# RECALL NOTICE

## ELECTRA BICYCLE COMPANY, LLC

### Amsterdam Model Bicycles: Potential Fall Hazard

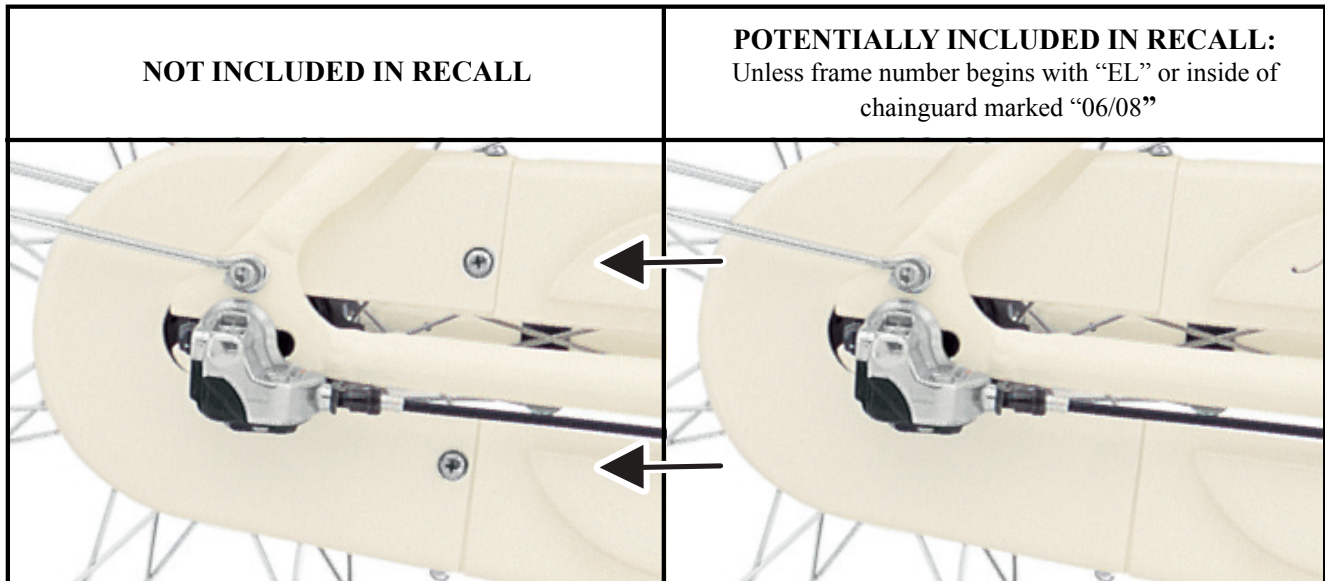
Chainguard

Location of Frame Number  
(Underside of Bottom Bracket)

If pushed against the chain, the bicycles's chainguard can derail the chain, creating a potential fall hazard. The recall includes certain Amsterdam bicycles in the Classic 3, Original 3, Royal 8 and Sport 3 styles. The recall does not affect bicycles in those styles with frame numbers beginning with "EL" or with chainguard marked "06/08". The recall does not affect bicycles with 4 screws connecting the front and rear chainguard pieces. The recall does not include Amsterdam bikes in the Balloon 8 and Sport 9 styles or any other Electra bikes.

Consumers should bring the bicycle to an Electra dealer. A replacement chainguard part will be professionally installed at no charge.
